Variance Request Form

Variance: VAR-016
 Request No.: Rev 0
 Date Submit: 07/07/17
 Date Agency Received:
 Agency Reference No.:

Variance 16 (VAR-016) is requesting a change in the means for installing underground (UG) collector line under McCain Valley Road (MVR) from boring to trenching in order to utilize the most efficient method and avoid the need for additional areas all while maintaining egress. Boring-and-jacking is specified in Mitigation Measure TRA-1 and in the Project's Traffic Control Plan when installing project components under an existing road. Boring is better suited for installation of the underground collector line under the paved portions of MVR under County jurisdiction, than along the portions of MVR under the BLM's jurisdiction where MVR has already been altered per the projects plans.

Tule Wind Project

Figure 2 Index
UGC Trenching in McCain Valley Road
Tule Wind Project

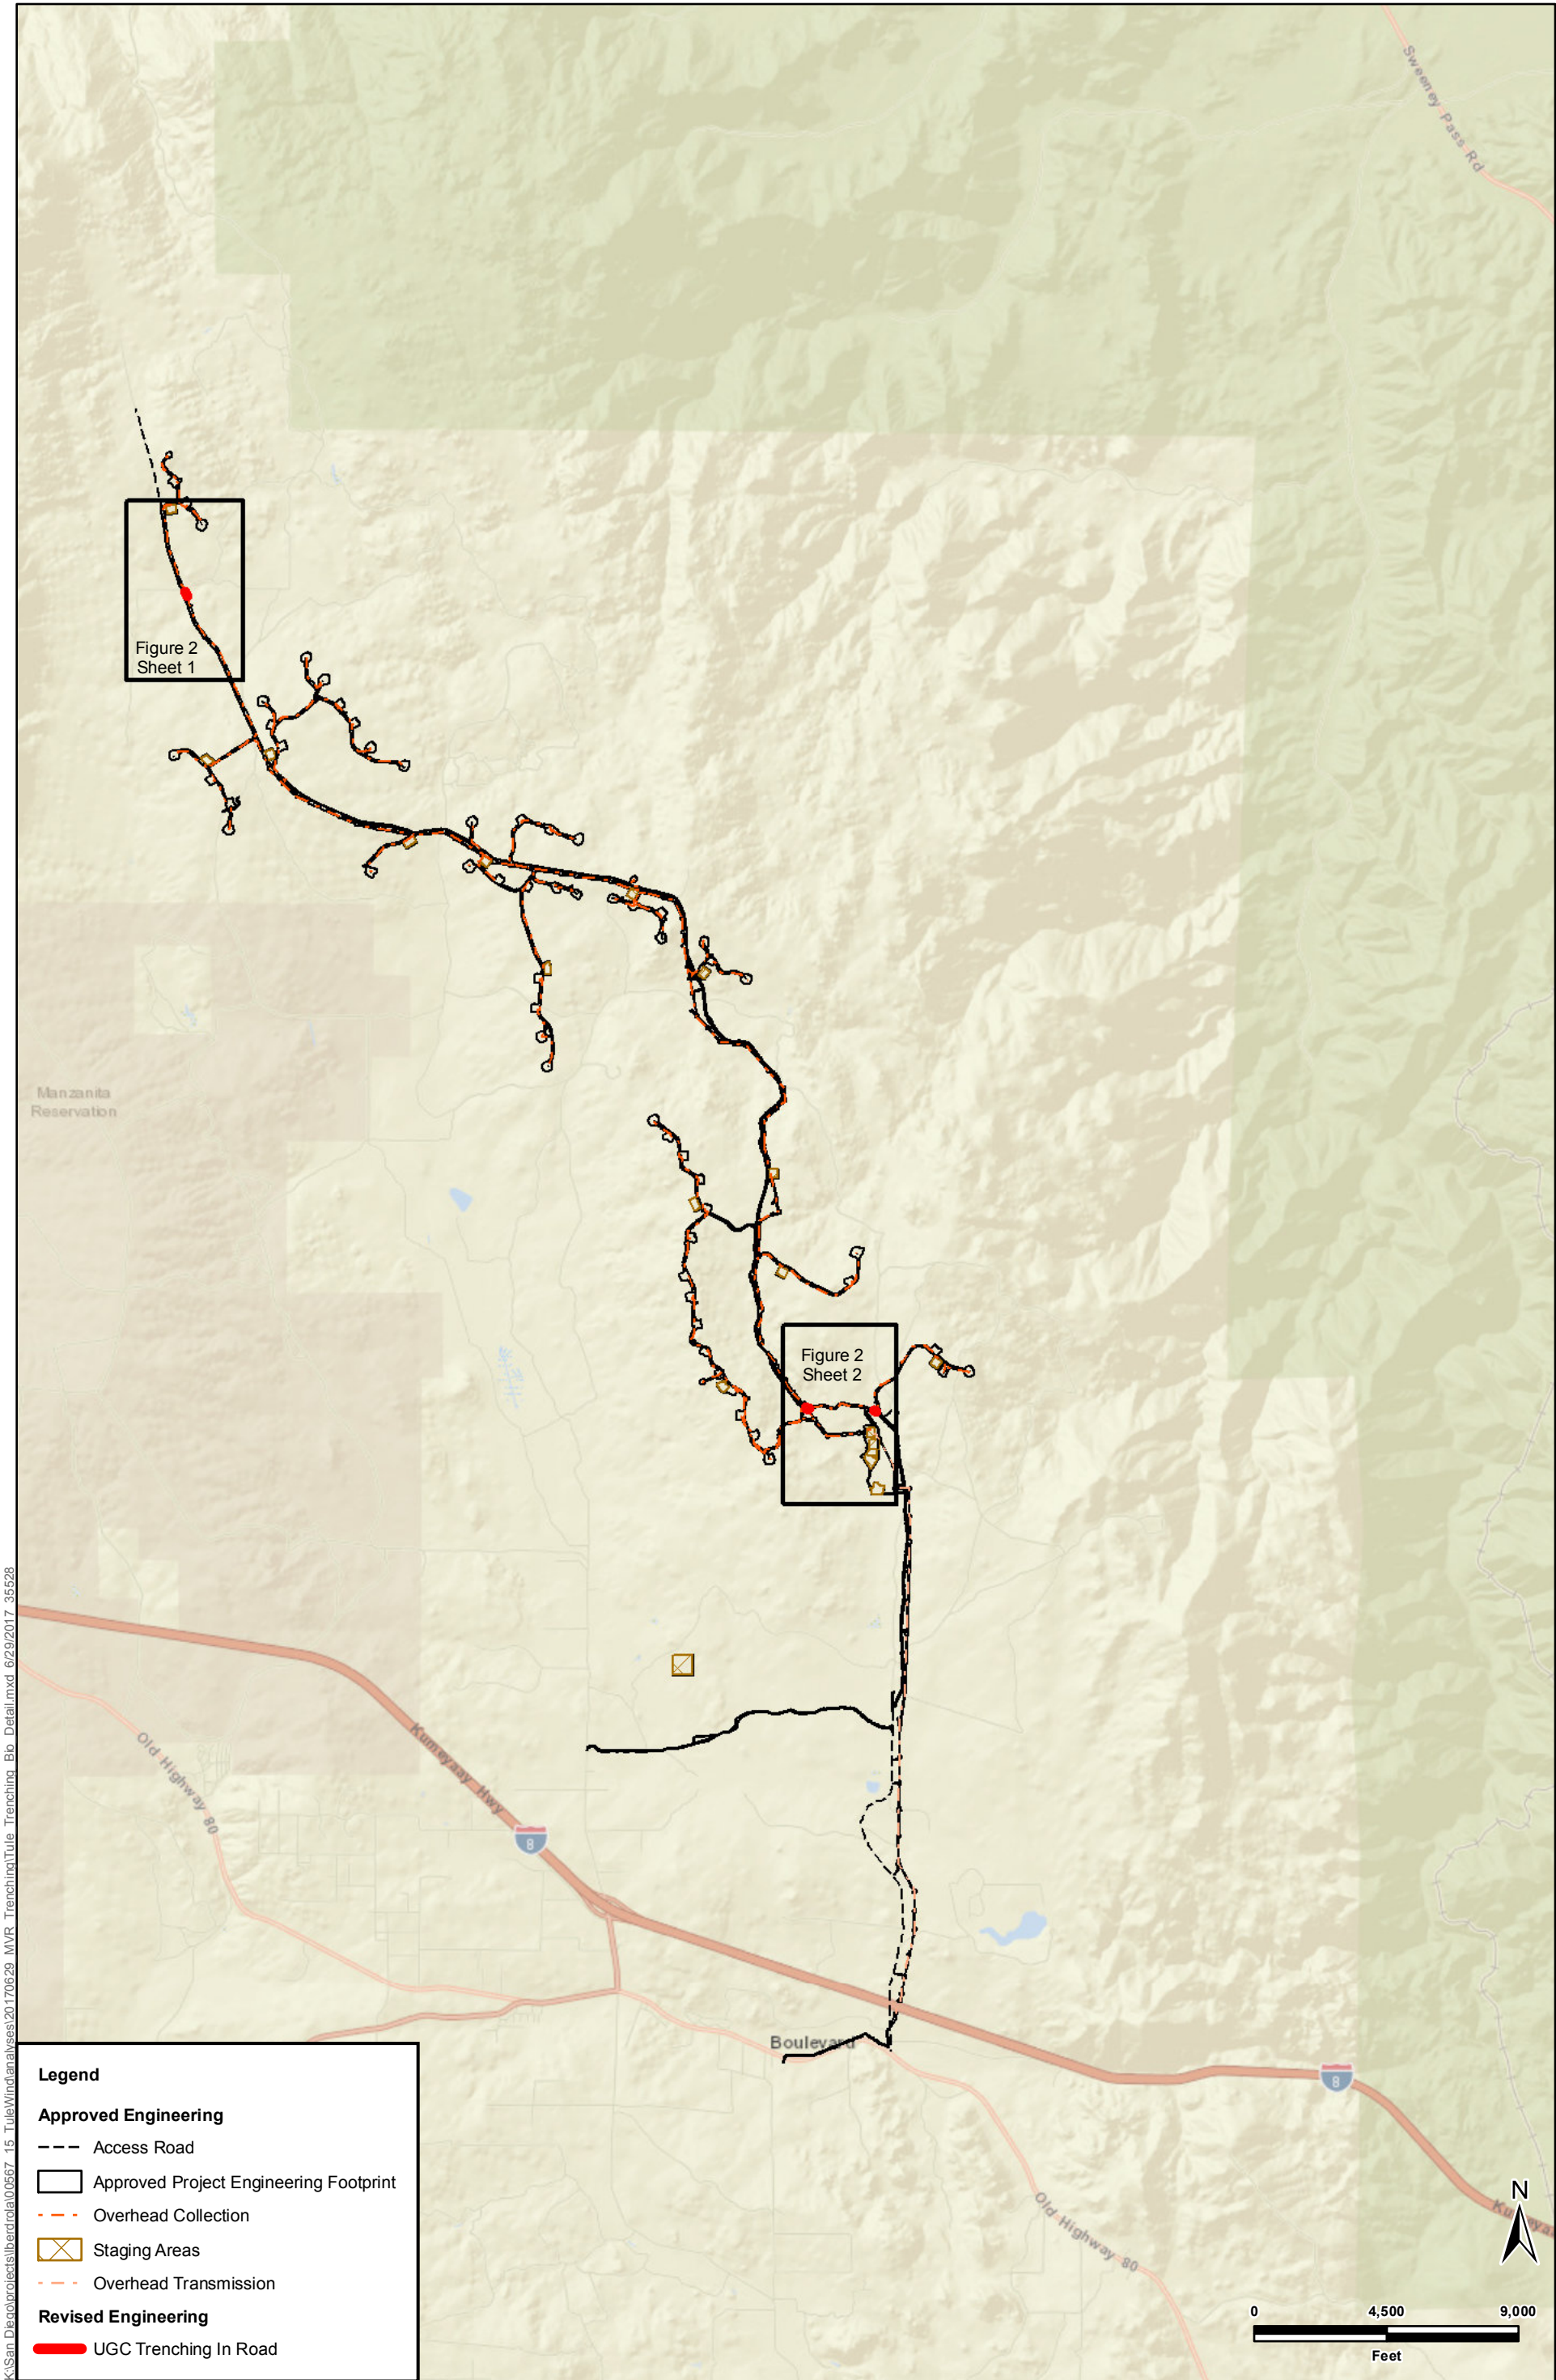
The proposed trenching method utilizes a PLC trencher, which digs the trench and lays the wire in one pass. A backhoe will dig a starter trench on one side of the road. The trencher will then trench ahead to the centerline of the road at an angle, which allows egress in front of the trencher. Once the trencher has trenched to this point and the wire is installed, the backfill equipment (skid steer, dozer and vibratory trench compactor) will backfill the open trench and egress will be allowed behind the machine. Once the installed section is completely backfilled and egress is provided over the backfilled trench, the trencher will then trench ahead to complete the road crossing. This process should take no longer than 30 minutes for each side of this crossing. Traffic will be slowed in the area where the work is being performed and flaggers will be used to direct traffic. See Attachment B for a diagram of this process. The scenario included in Attachment B is the narrowest of the MVR crossings and a similar set-up will be used for all other crossings. In some locations traffic may be stopped for a short period of time (10 minutes) as the trencher moves across the road and compaction is occurring. In the event of an emergency equipment will be moved and vehicles associated with the emergency situation will be allowed to cross. This change in methodology would take place at the locations previously identified for crossings in the approved plans and the additional locations identified on Attachment A, Figure 1..

Figure 2 Sheet 1
UGC Trenching in McCain Valley Road
Tule Wind Project

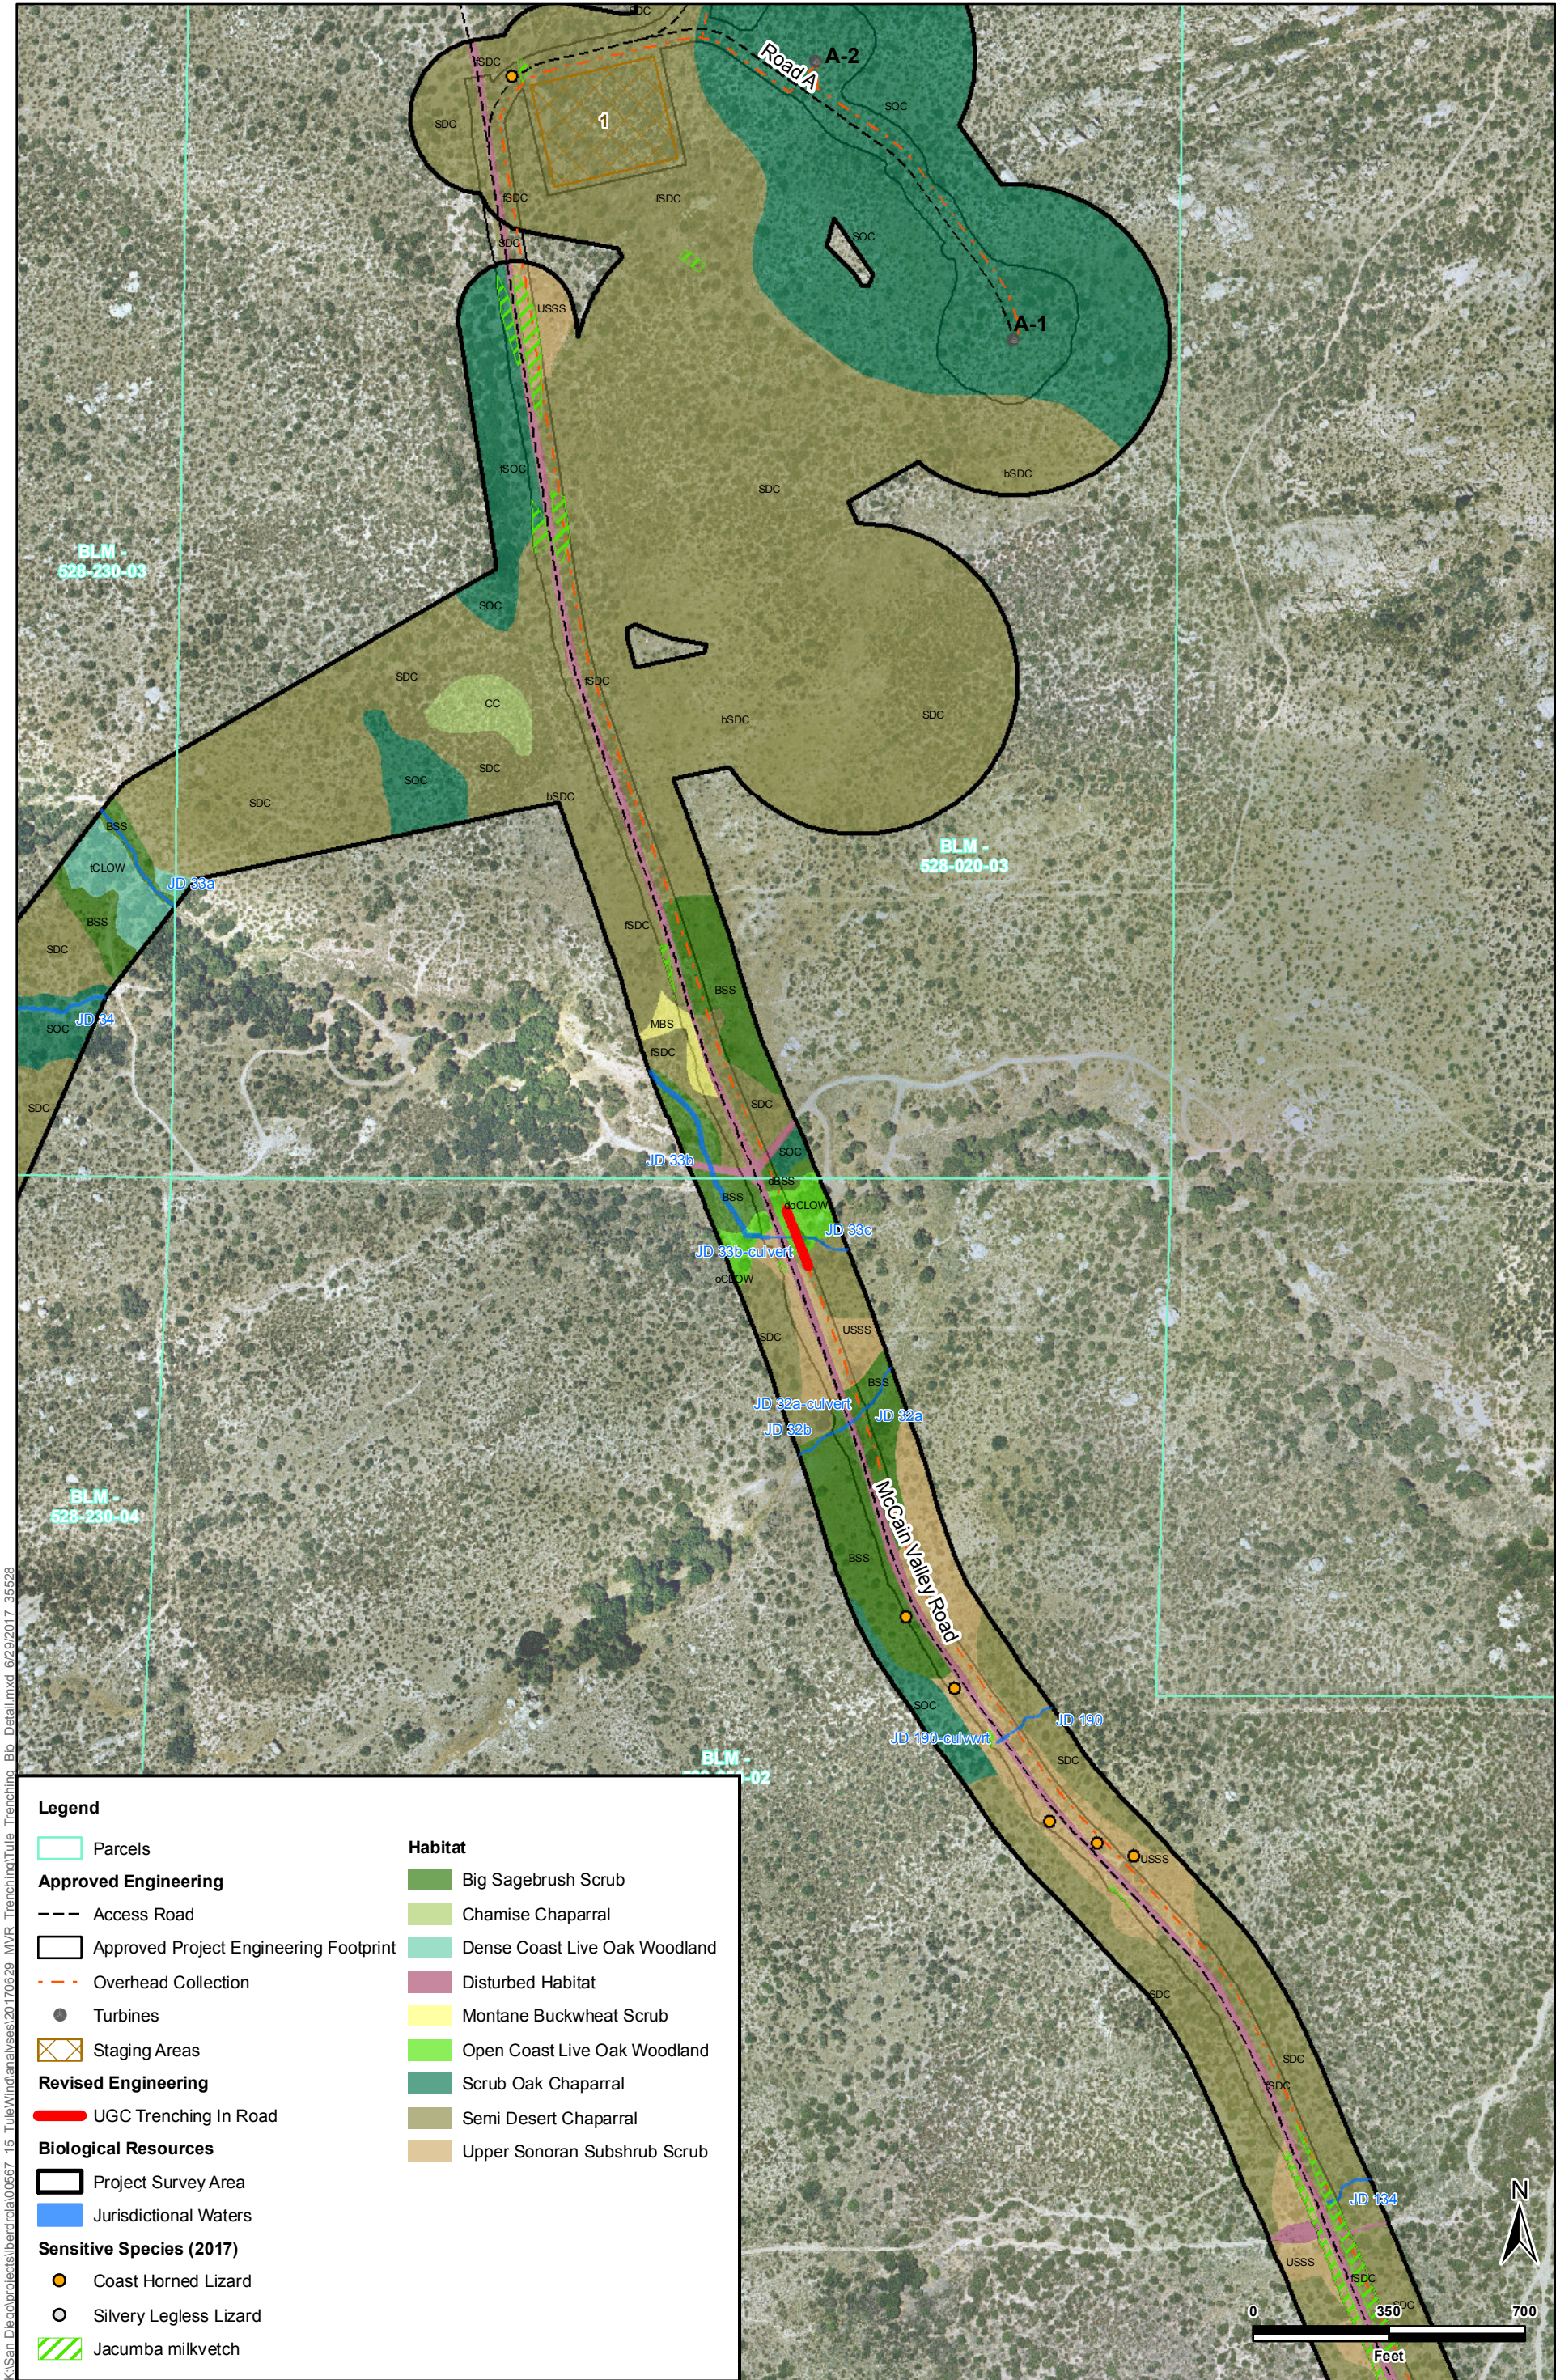
Where underground collection line needs to be installed beneath MVR to avoid sensitive resources, trenching using the PLC will install the UG collector line parallel with the road, staying on the road's edge. The trencher's dimensions are 8 feet, 2 inches in width by 45 feet in length and will be installed along one of the road, therefore allowing egress on the opposite side of MVR. This type of trenching takes approximately one hour per 100 linear feet, and would occur at three locations including two sections between J & G and one between A and B (Attachment A, Figure2).
